**Nomination for Waters Important to Anadromous Fish**

Anadromous Water Catalog Number of Waterway: 182-70-11400-2010-3009-4039
Archive 6015

Name of Waterway: Seal Creek ☑ USGS Name ☐ Local Name

SealStrms9-12.jpg

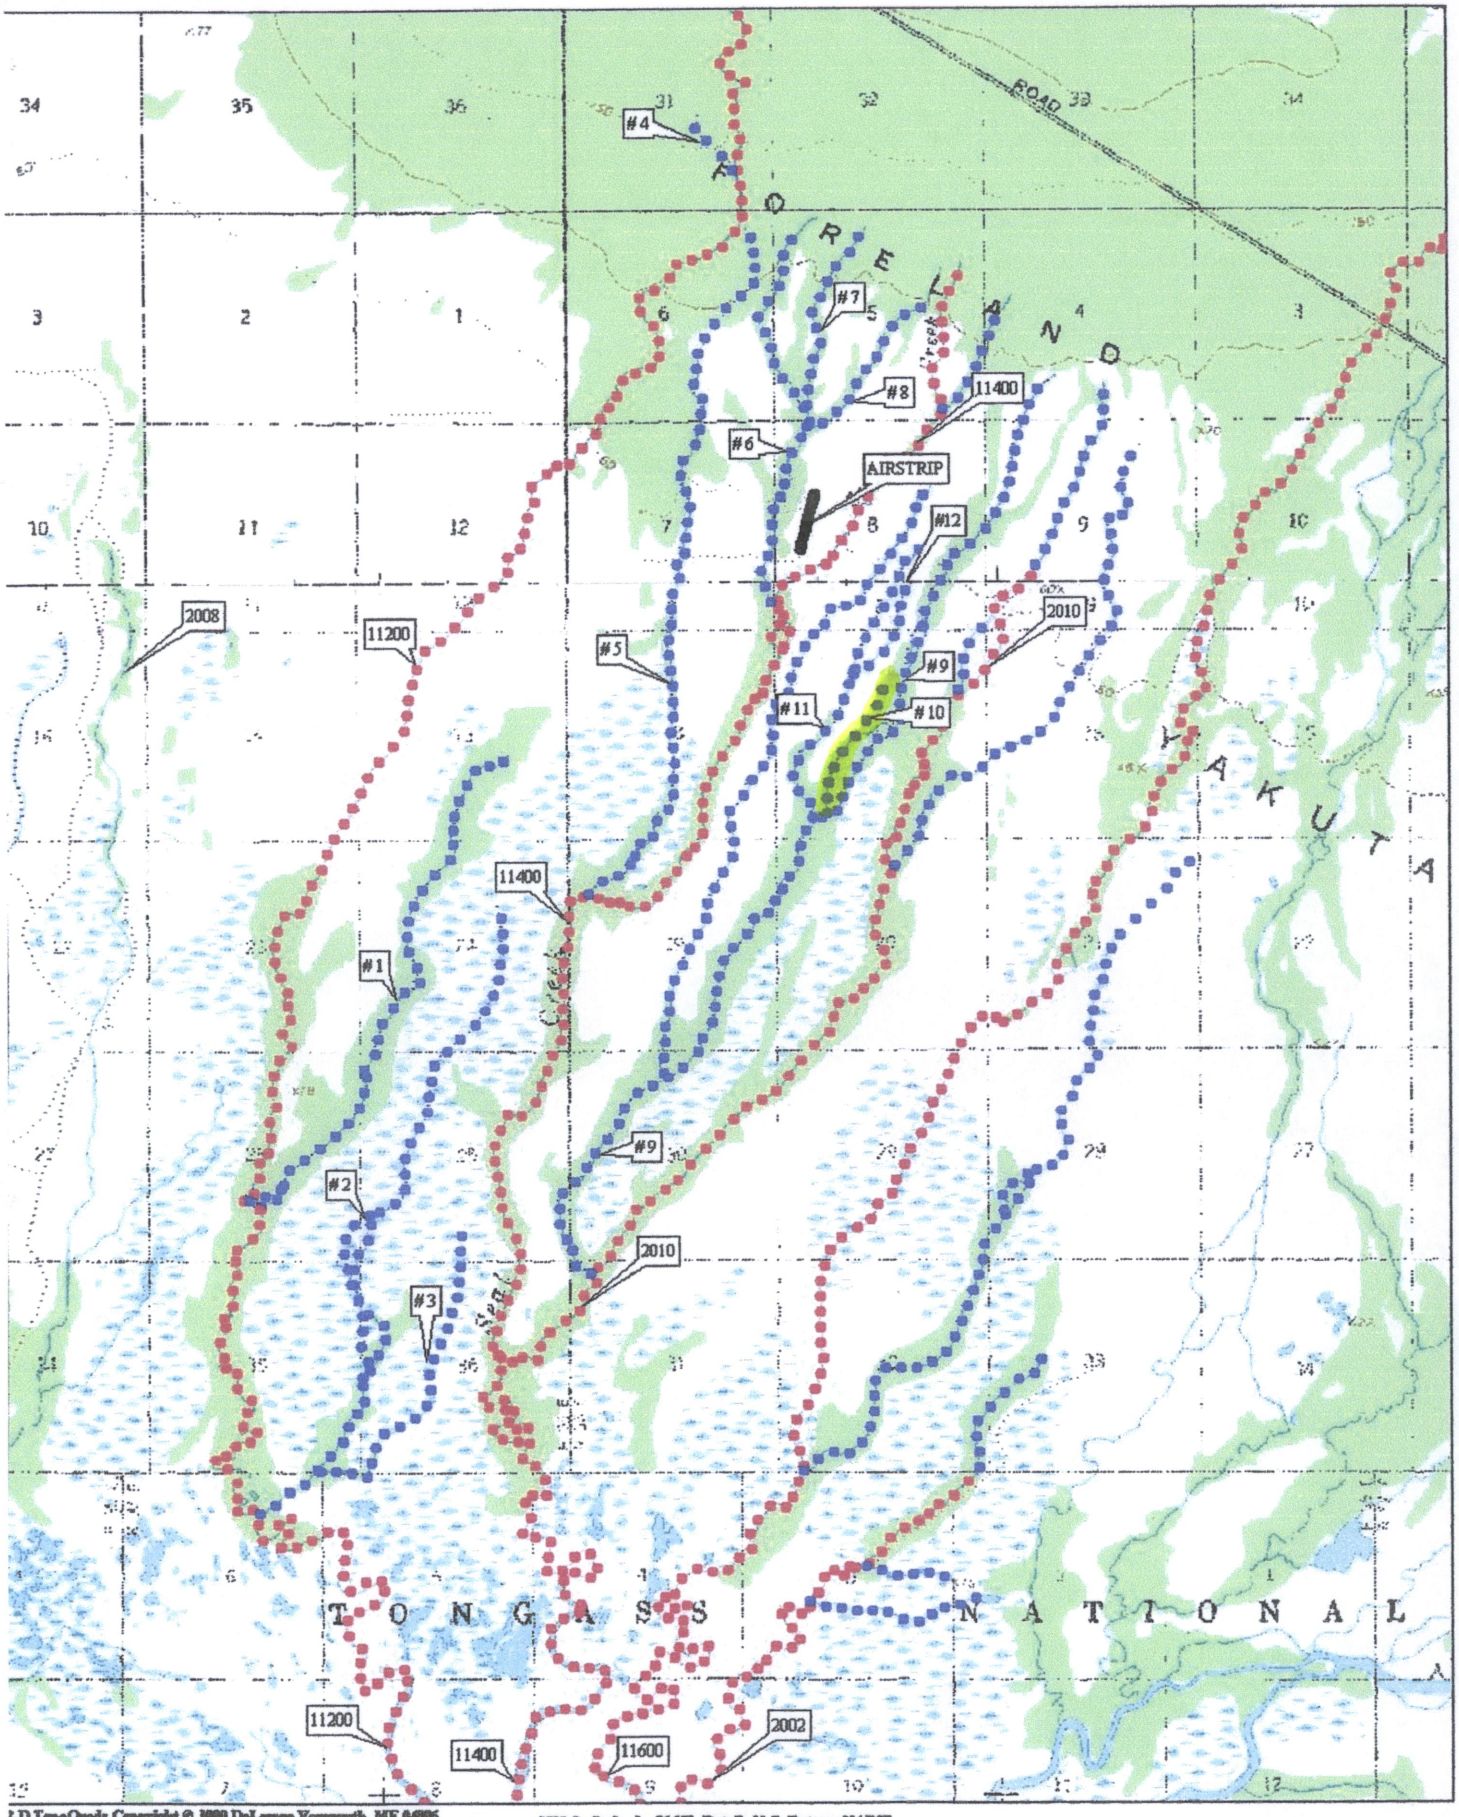
Add stream 182-70-11400-2010-3009-4039

SealCrkQ2X.jpg

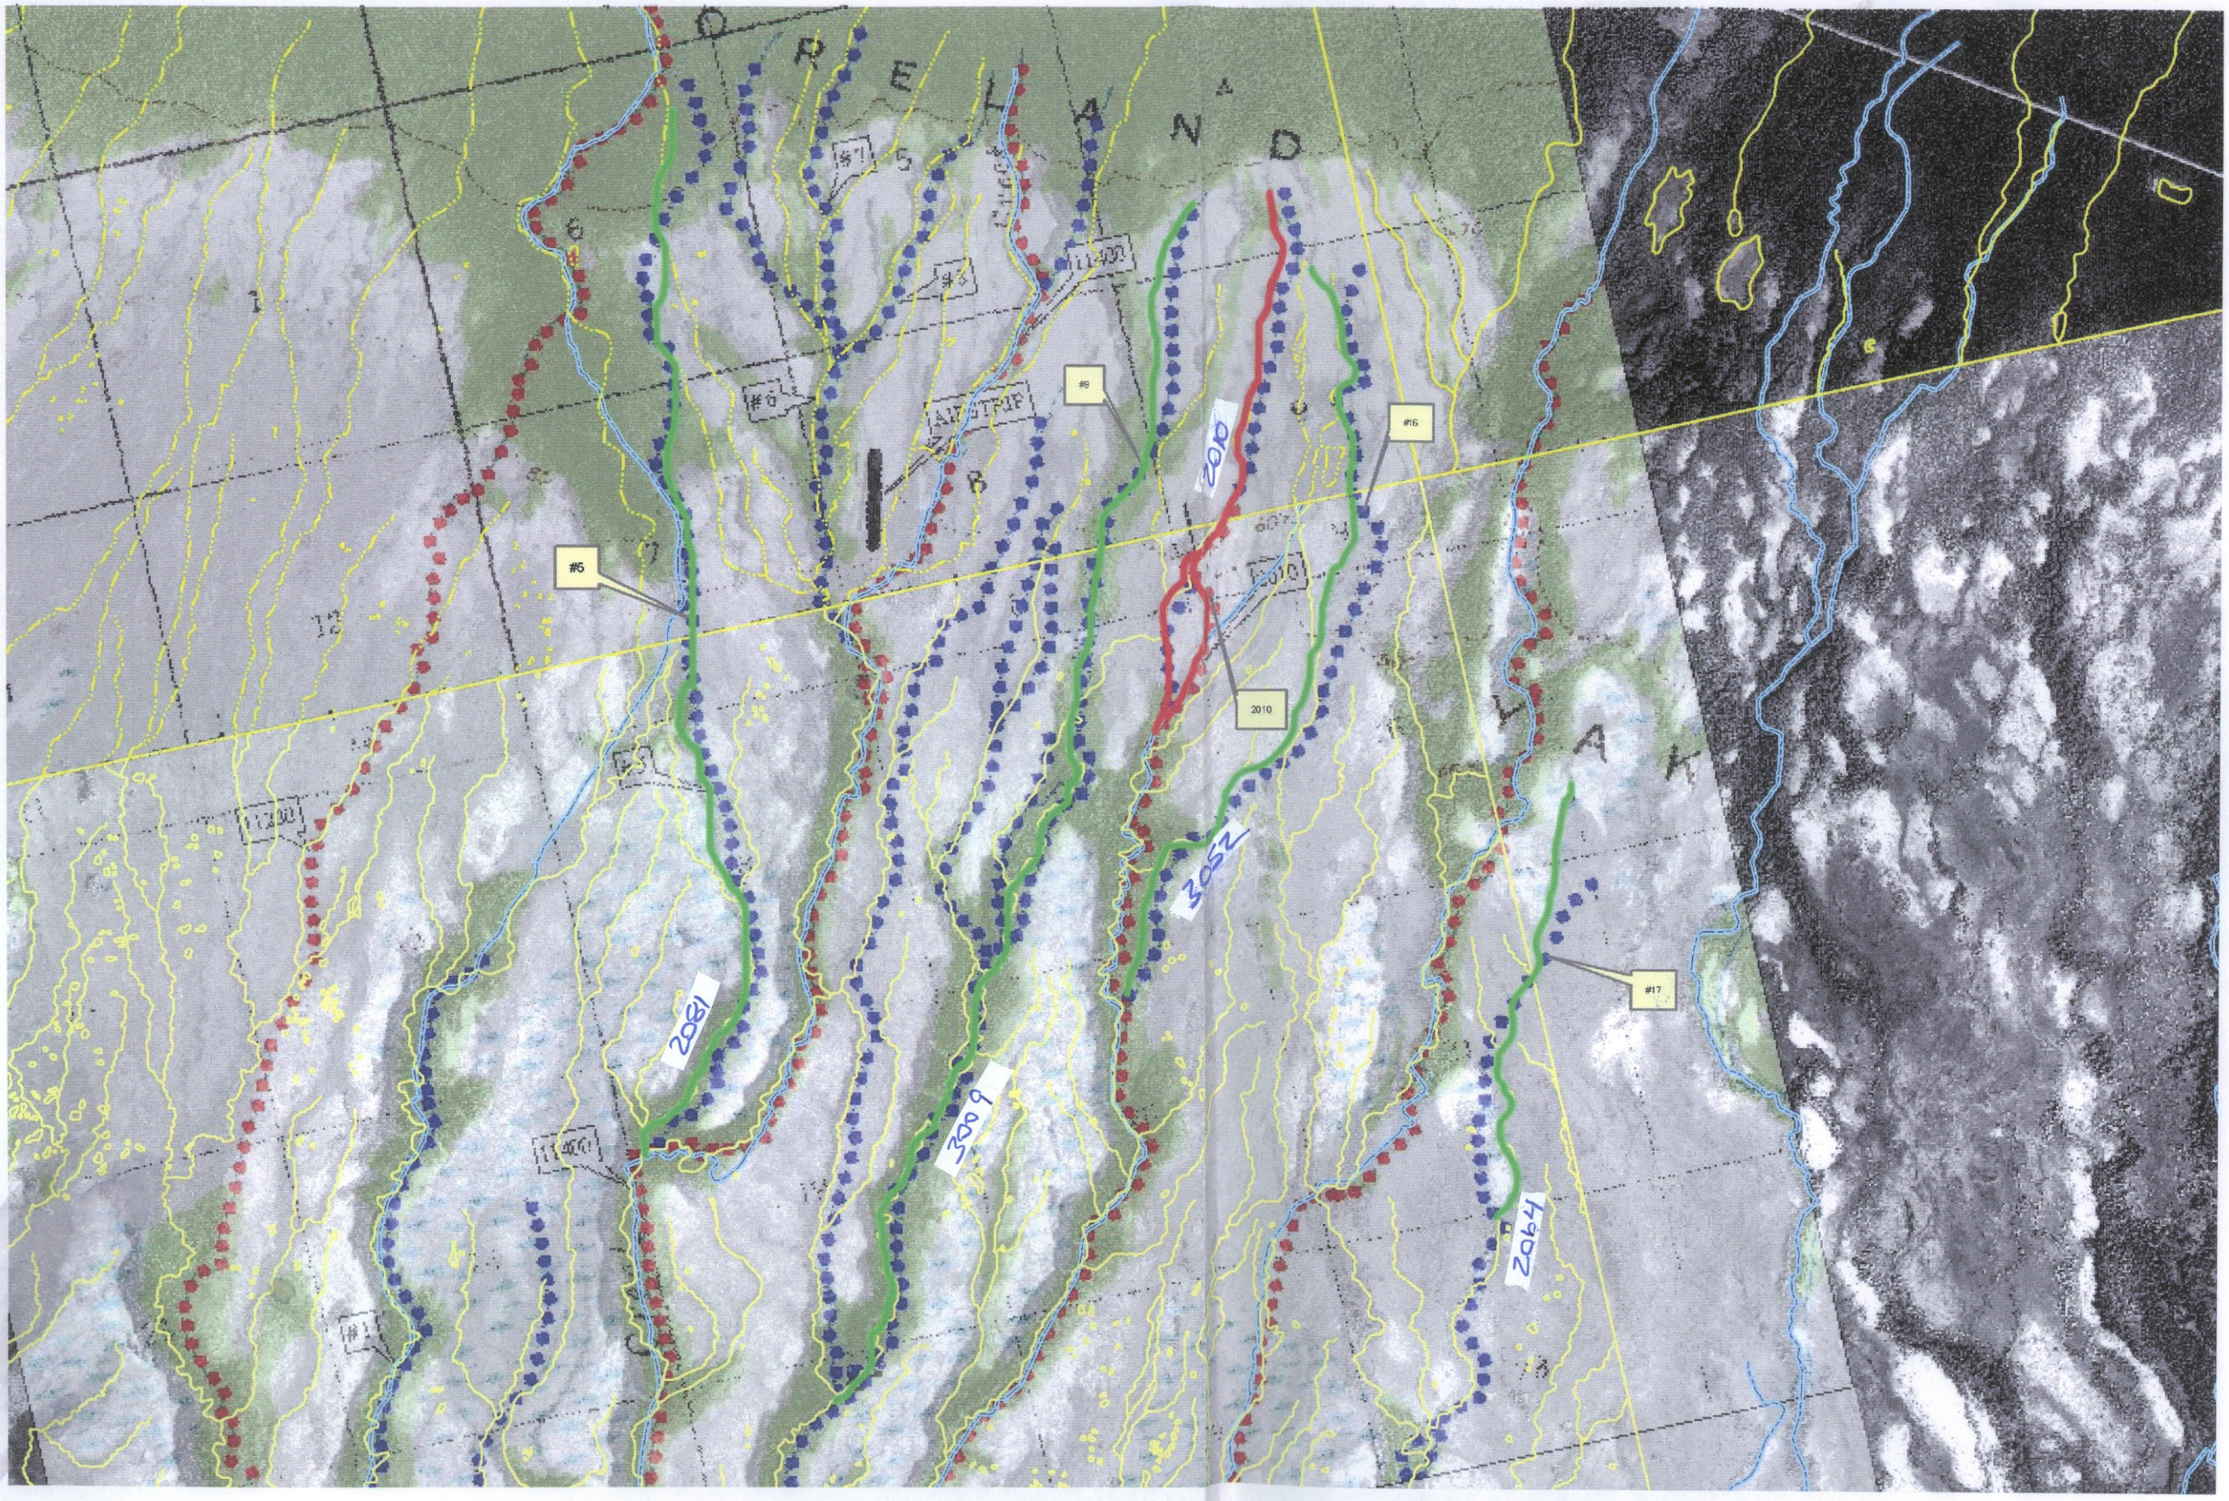
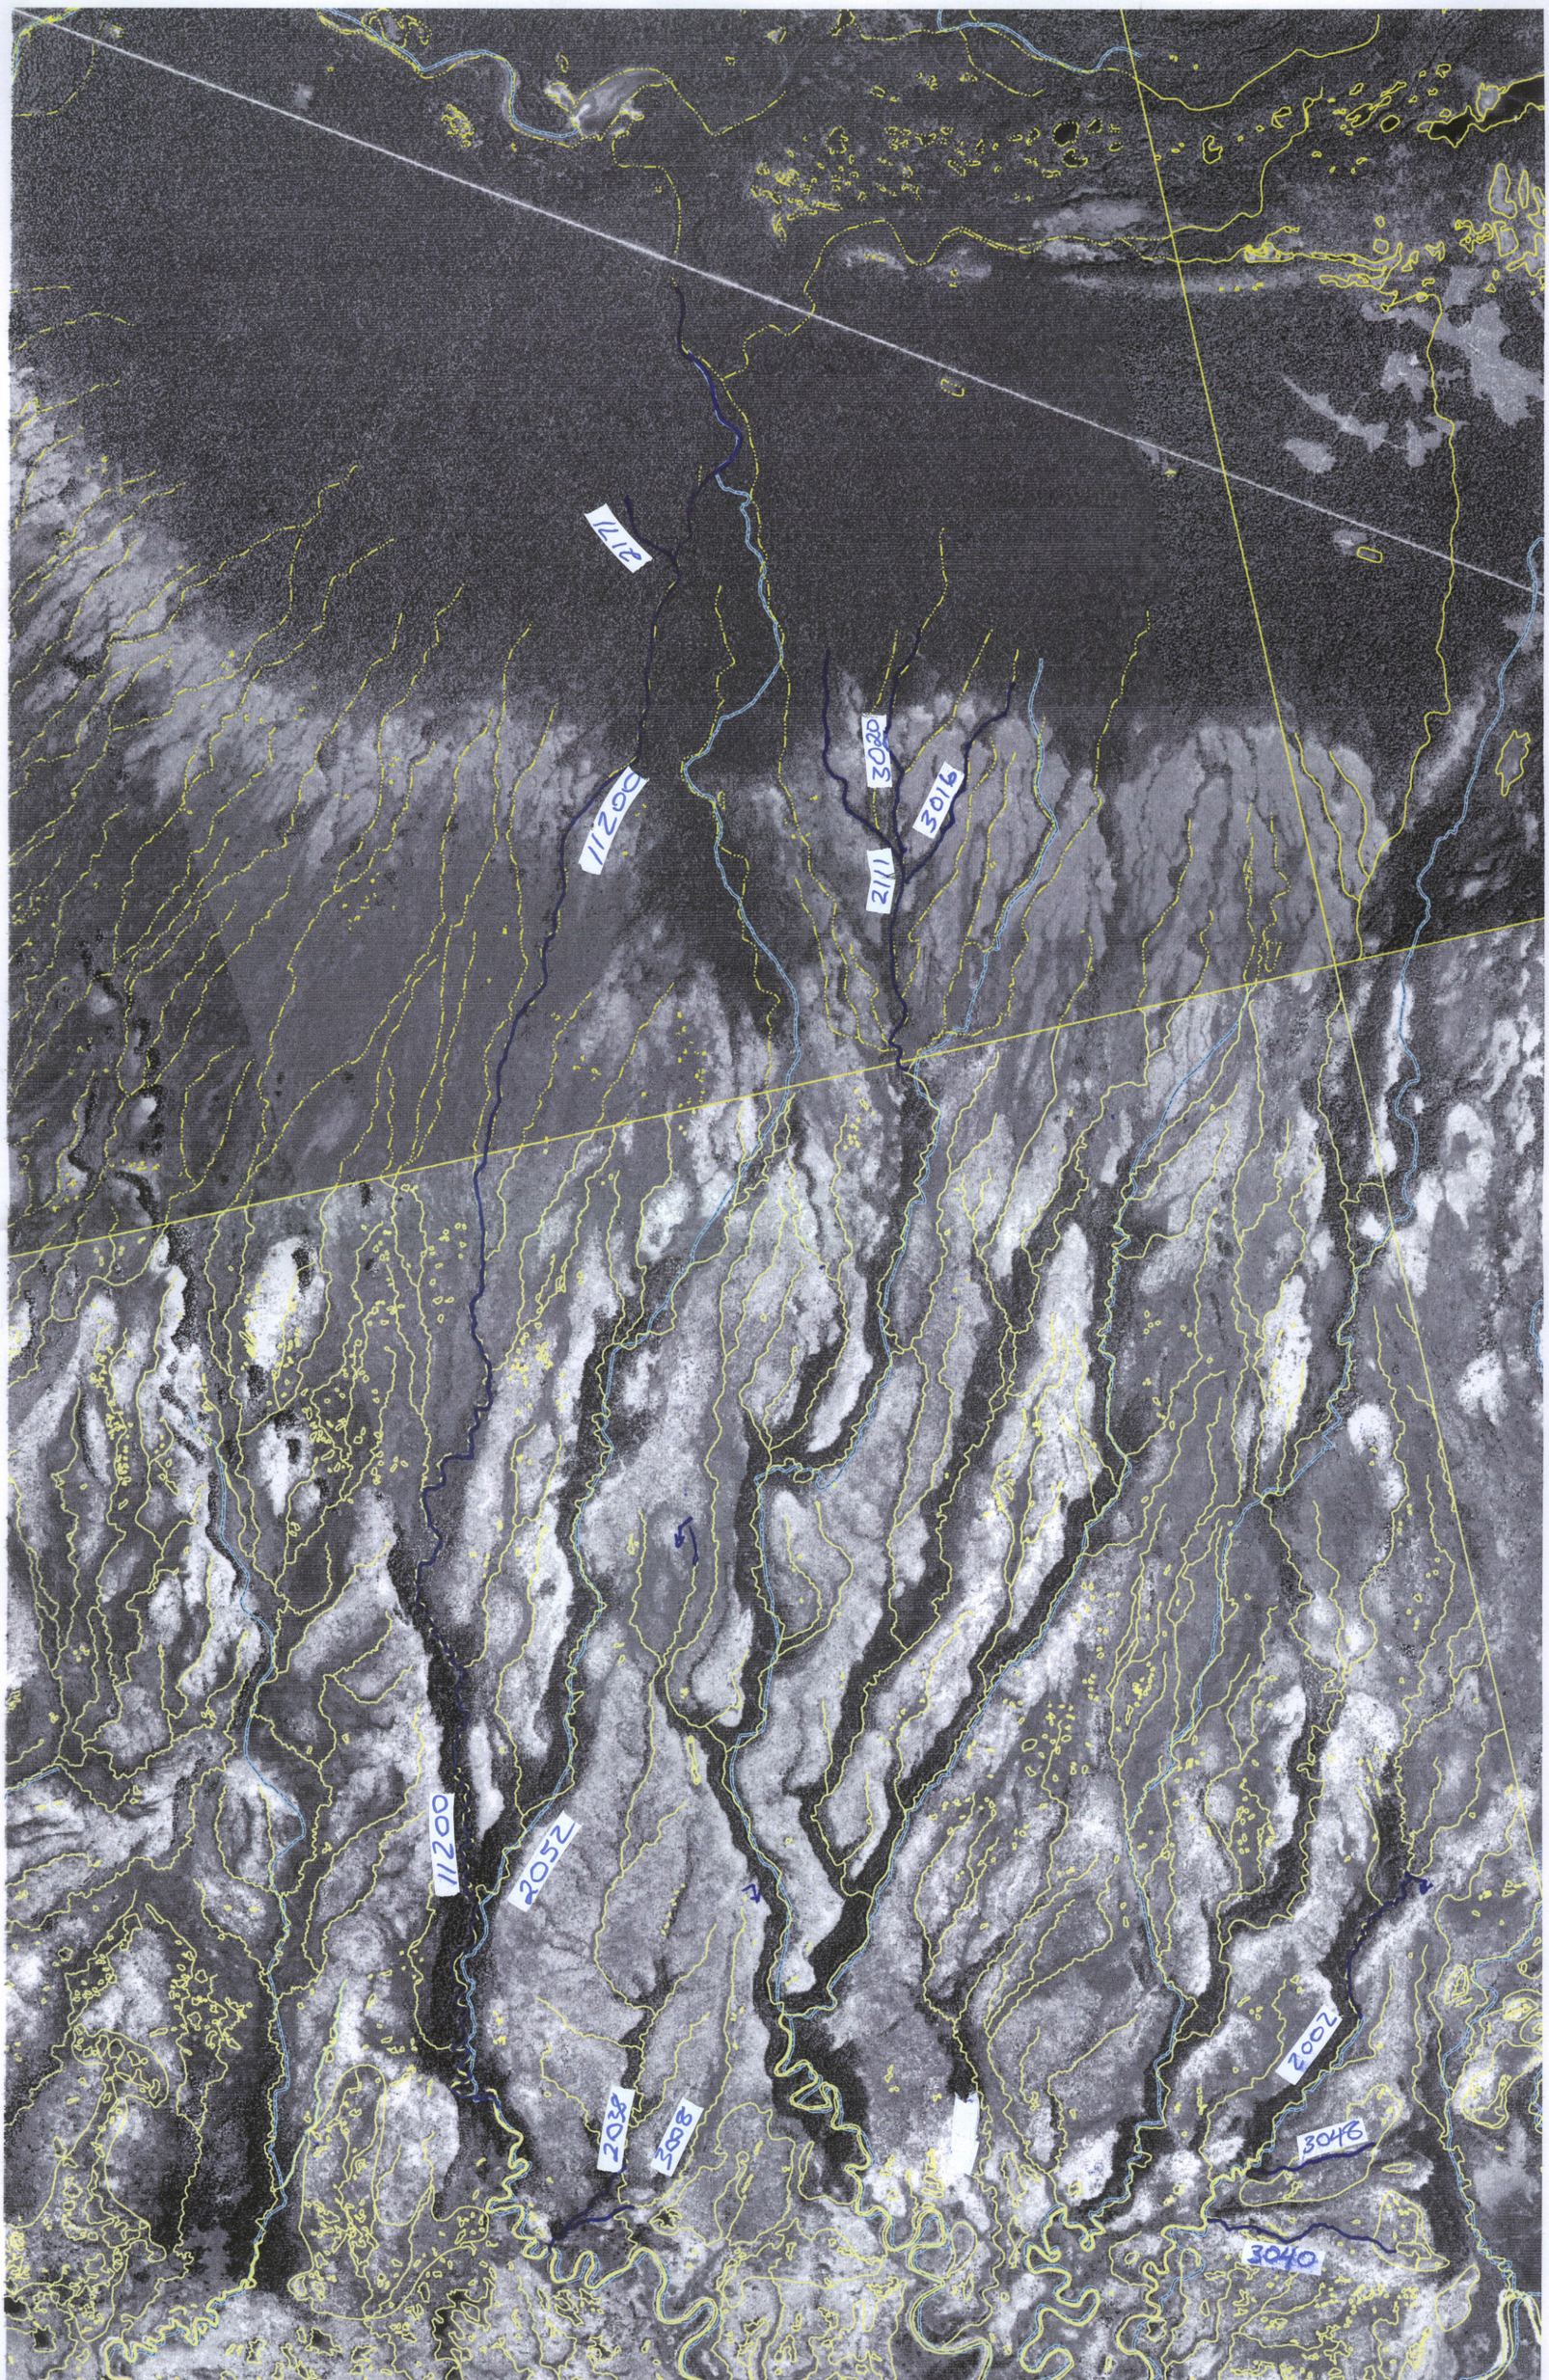
MOVE HYDRO FOR 11200 AS NOTED. ALSO NOTE CHANGES TO UPPER & LOWER ENDS of 2038

Looks like a few more of these are jumping between the different hydro streams that I have. Can you look at the attached Jpeg and let me know where the stream should lie for streams 5, 9, 16, 17 and there's also something going on there with the upper section of 2010. I've overlain your original submittal with the hydro and photo in the jpeg.

Ed - here's the modified jpg for this. This was is pretty tough because of the beaver dam activity throughout this upper area re-routing water every-which-way. My best guess.... Phil
